BID ADDENDUM NO. 1

PROJECT NAME: KING STREET ELEMENTARY SCHOOL
BOILER REPLACEMENT
SED #: 66-19-04-03-0-007-015

DATE: February 16, 2023

DRAWING KSES H201 – KING ST ES LEGEND, NOTES, BOILER PLANS AND SECTIONS

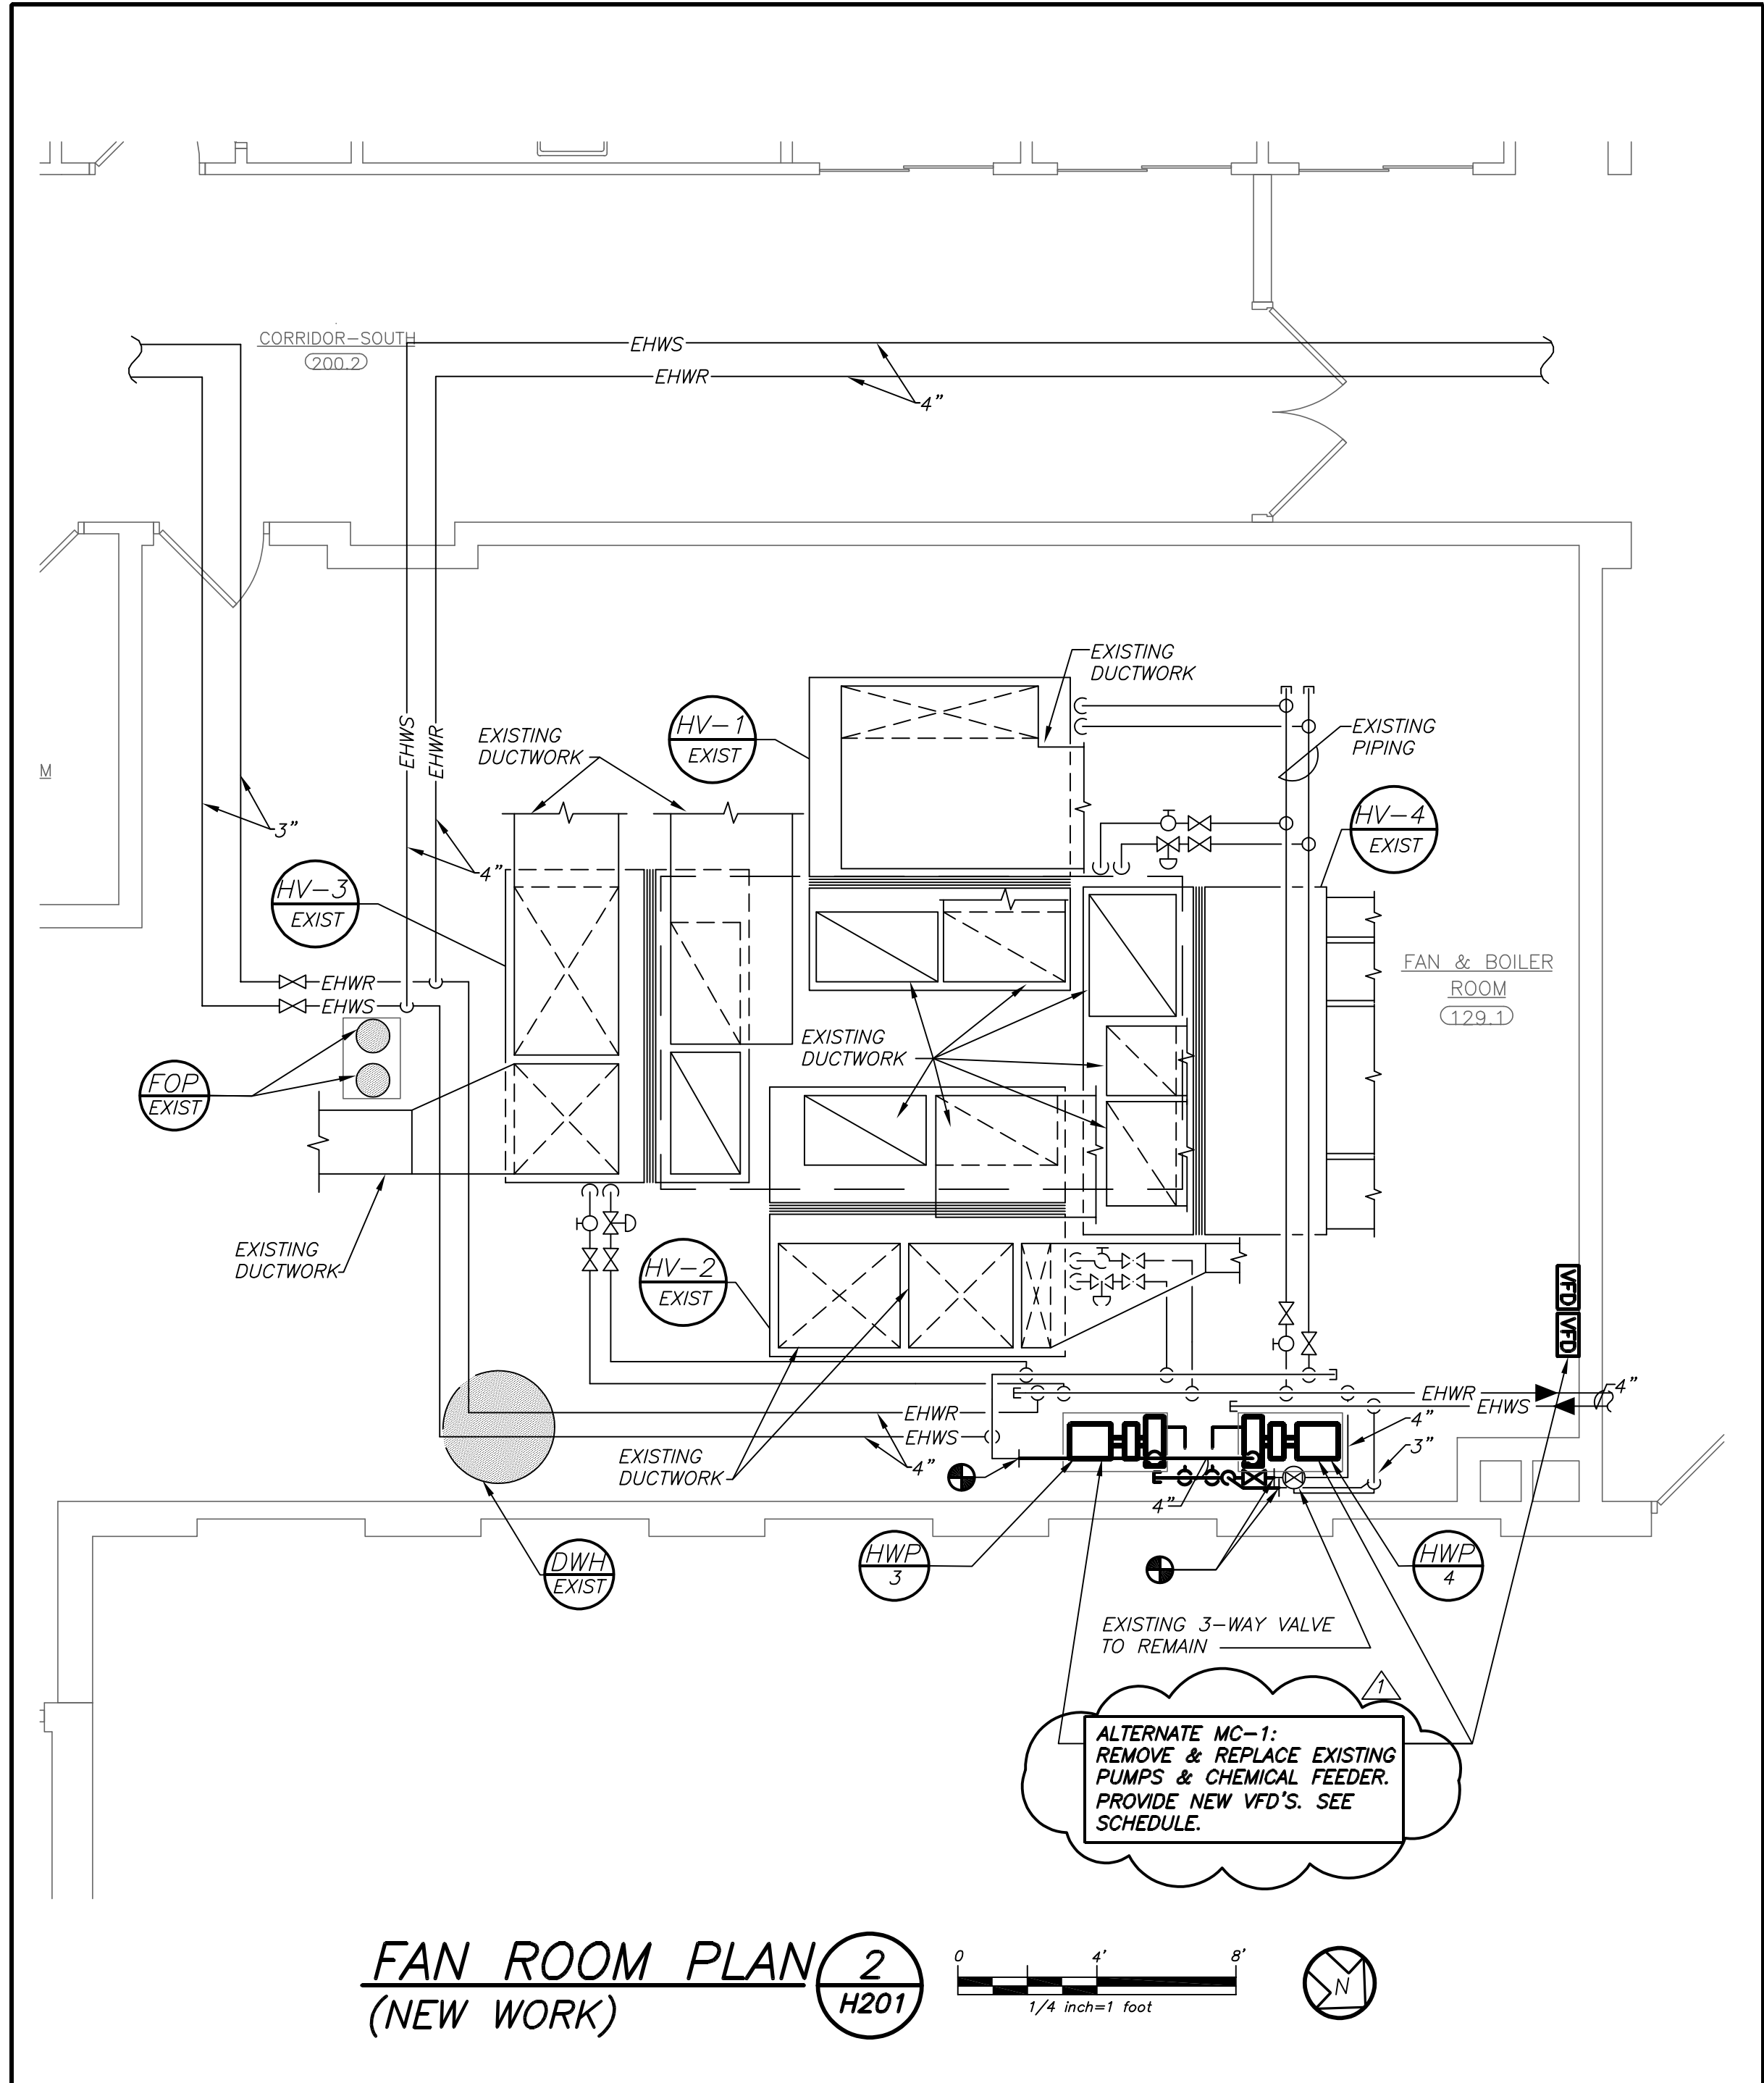
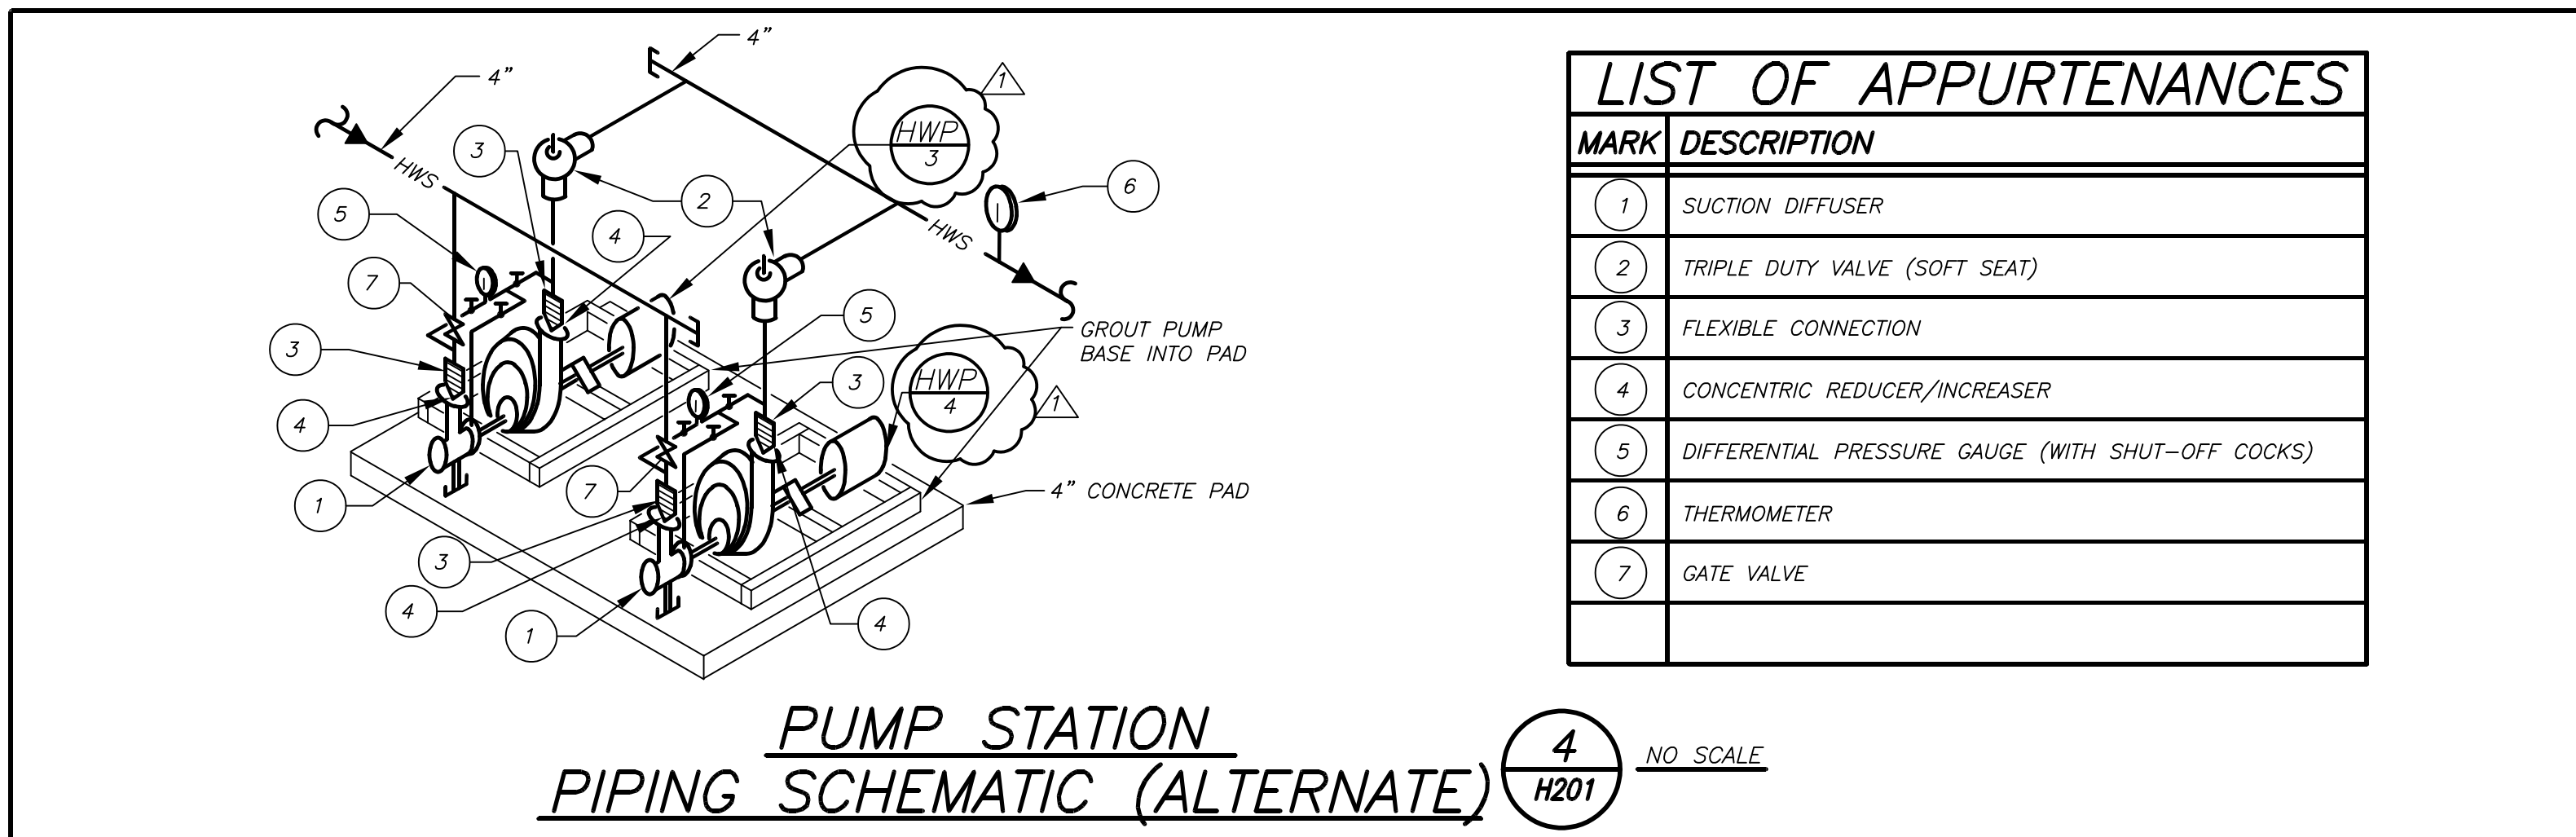
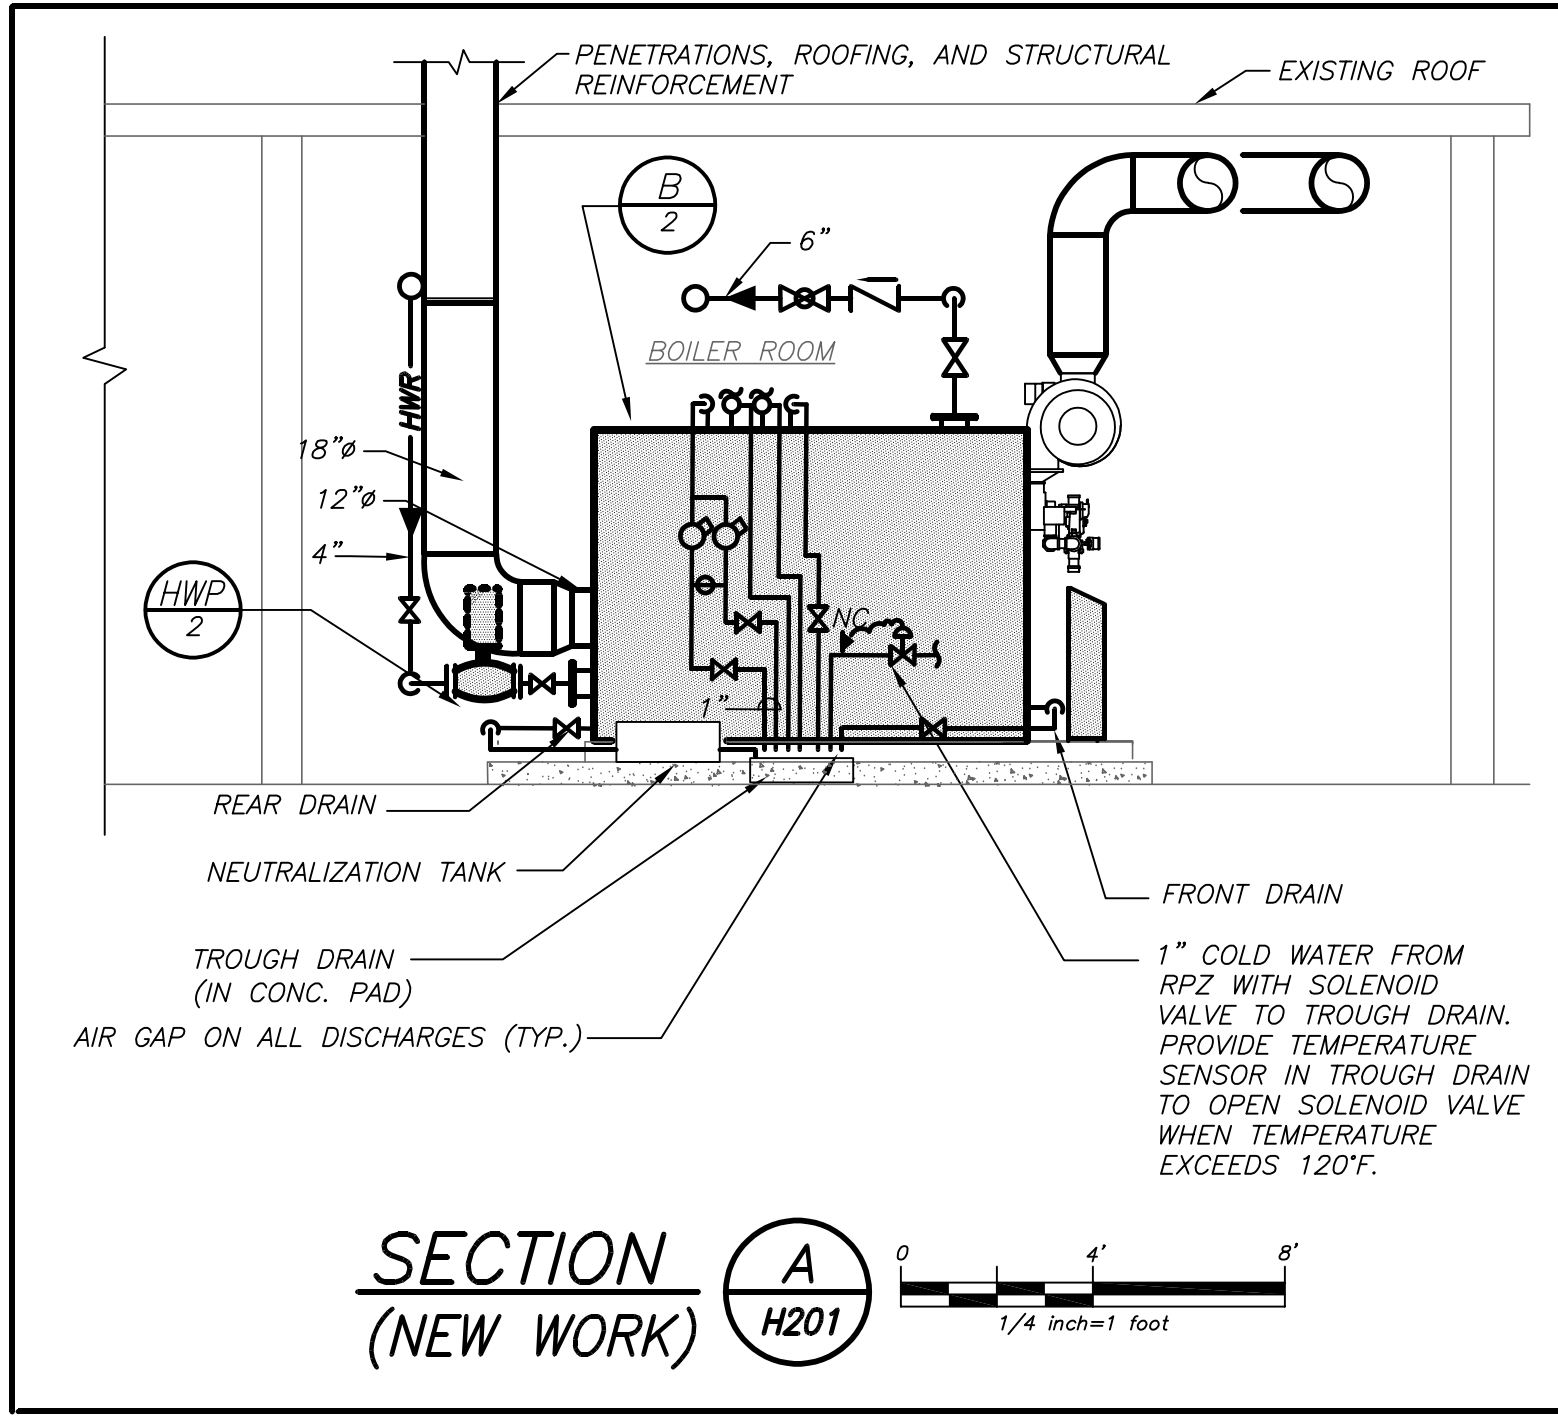
- 1. 1/H201 – BOILER ROOM PLAN (REMOVALS)
 - a. Include note “Boiler gaskets and burner lining shall be removed by abatement contractor pending ACM report.
Coordinate with abatement contractor”. See attached drawing.
- 2. 2/H201 – FAN ROOM PLAN (NEW WORK)
 - a. Modify note for Alternate MC-1 to include chemical feeder. See attached drawing.
- 3. 3/H201 – BOILER ROOM PLAN (NEW WORK)
 - a. Include note “Replace all vibration isolators on piping”. See attached drawing.
- 4. 4/H201 – PUMP STATION PIPING SCHEMATIC (ALTERNATE)
 - a. Replace tags HWP-1 and HWP-2 with HWP-3 and HWP-4. See attached drawing.
